# Pennsylvania Technical Advisory Committee

## Diesel Powered Equipment

## Engine and Filter Evaluation

### Evaluation of the Nett technologies Diluter

Fig 1

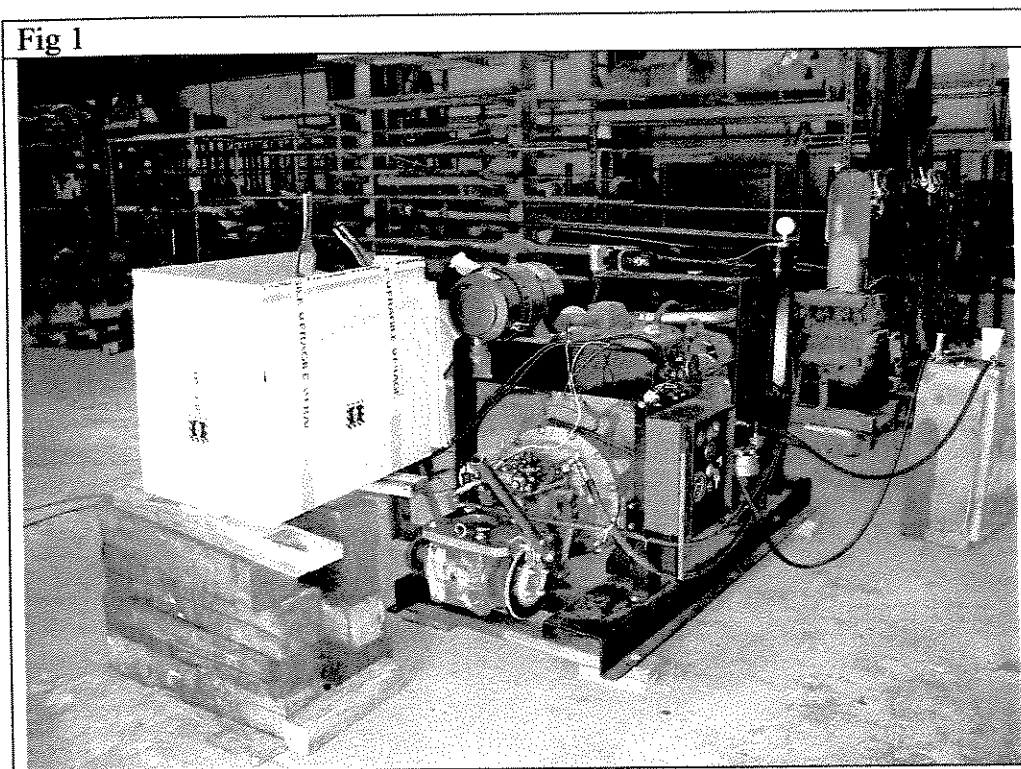
The purpose of the diluter is to mix ambient air with the exhaust to lower the temperature of the exhaust gas below the required 302<sup>0</sup> F. The diluter was encased in a box to simulate the final configuration of this device (Fig. 1) The ambient air entering the box was measured with an anemometer during high idle condition. The amount of ambient air entering the box was found to be approximately 690 CFM. I believe this to be about a 1 to 1 ratio of exhaust and ambient air. We then attached a thermocouple probe (J configuration) to the diluter approximately ¾ of an inch into the exhaust stream (Fig.2). The test protocol used for this evaluation was as follows:

Fig. 2

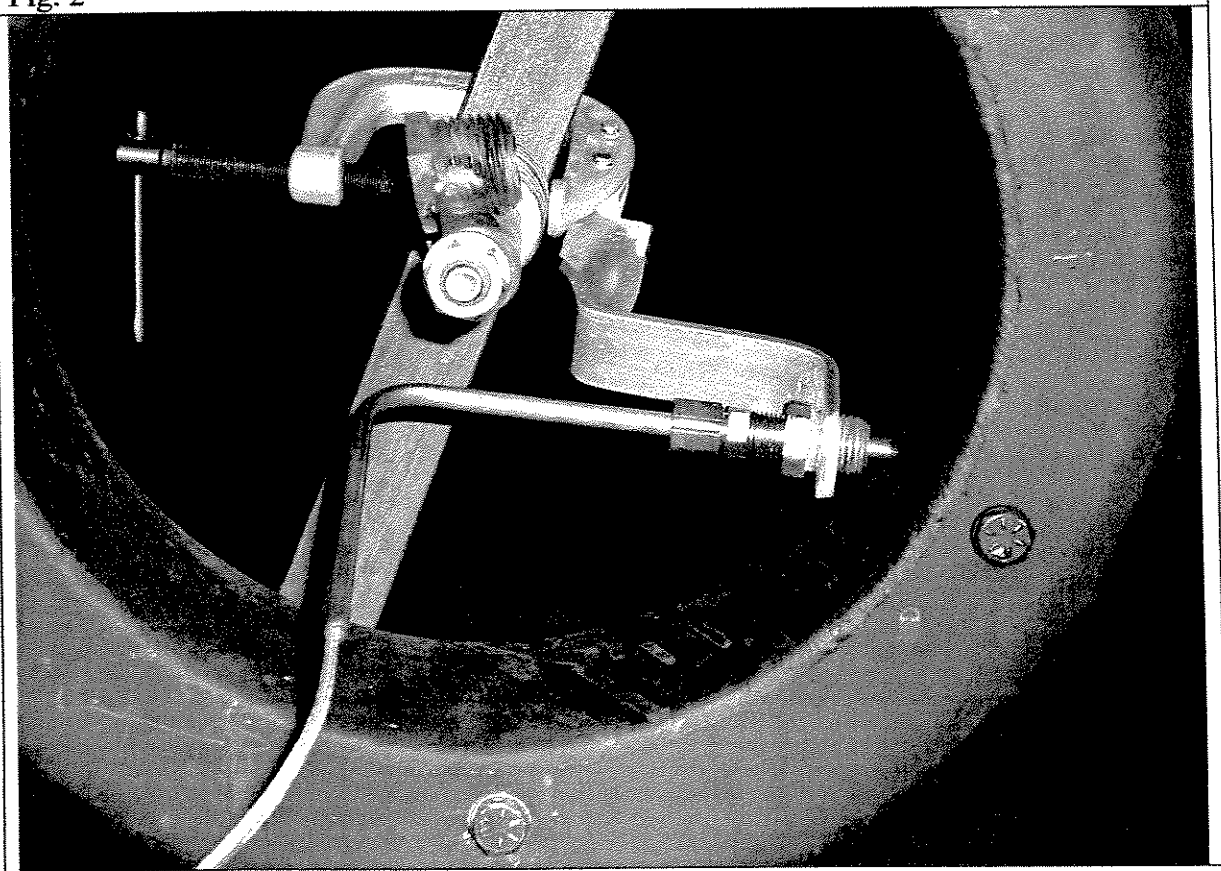
After the second series, the exhaust gas temperature increased above the 302<sup>0</sup> F requirement (Chart 3). The test was stopped at this time. After studying the setup of the diluter we found that even though the thermocouple probe was located ¾ of an inch in by the outside edge of the diluter the position of the box caused the probe to be positioned 2 ½ inches in by the outer edge of the box. At this time we adjusted the thermocouple probe to be even with the outside edge of the diluter and approximately 1 1/2 inches into the exhaust stream. (Fig.3) We felt this would be acceptable since Pennsylvania law requires the exhaust gas to be under the 302<sup>0</sup> F just prior to entering the mine

- It is clear that the position of the exhaust gas temperature shutdown will be critical to the use of this technology.
- If the probe is set too far in by the outer edge of the diluter it will not give an accurate reading of what the temperature of the exhaust gas is prior to entering the mine atmosphere.
- On the other hand if the probe is mounted beyond the outer edge of the diluter we would not be able to tell if the exhaust gas temperature requirement is being met.
- At this time I suggested that a small fan be installed that would increase the flow of ambient air into the diluter during periods of heavy duty cycle. I stated that it would not be necessary to have the fan run constantly but rather have the fan wired to turn on at about 250 degrees F. If this is done properly the Nett Technologies Diluter should meet all Pennsylvania requirements.

Chart 3

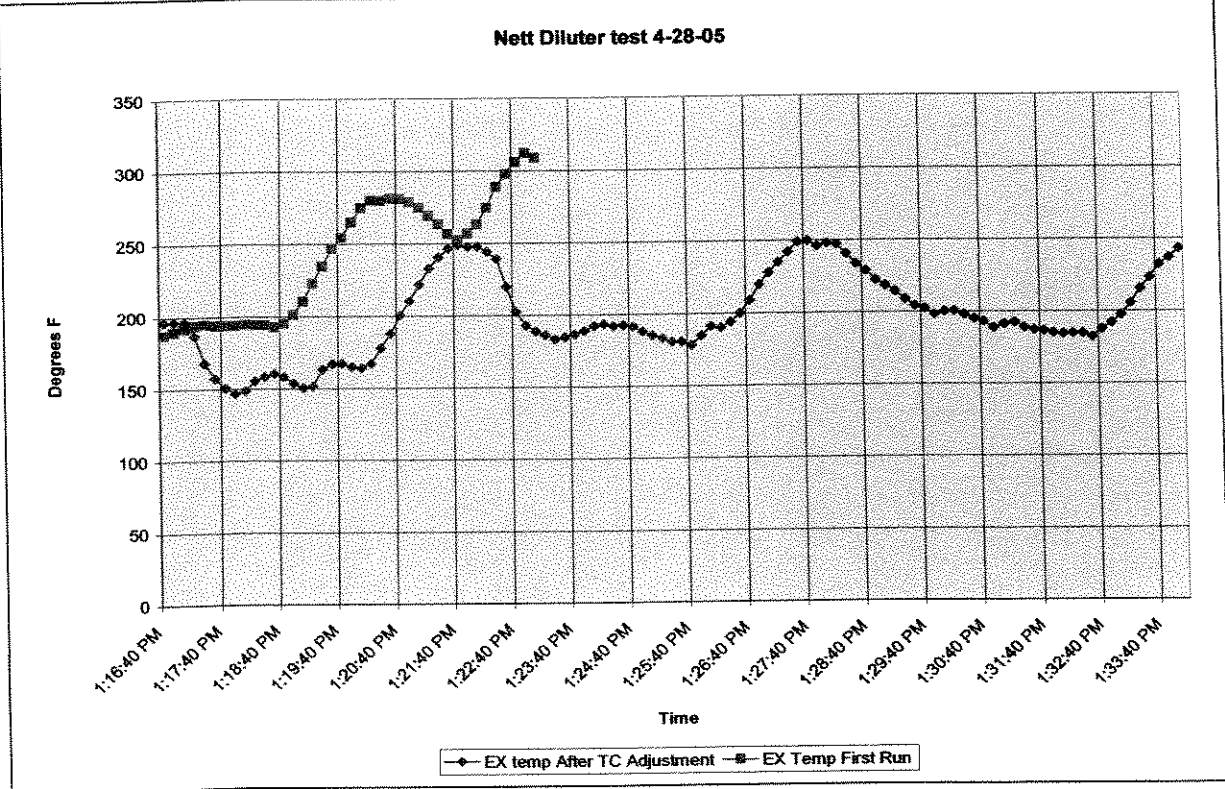
Unlike the first test, the diluter did maintain the exhaust gas below the Pennsylvania requirement during the entire test. (approx 17-minutes) The diluter seemed to set a trend during the testing with the high idle periods ranging from 167 to 192<sup>o</sup> and stall condition ranging from 243 to 252<sup>o</sup> F.
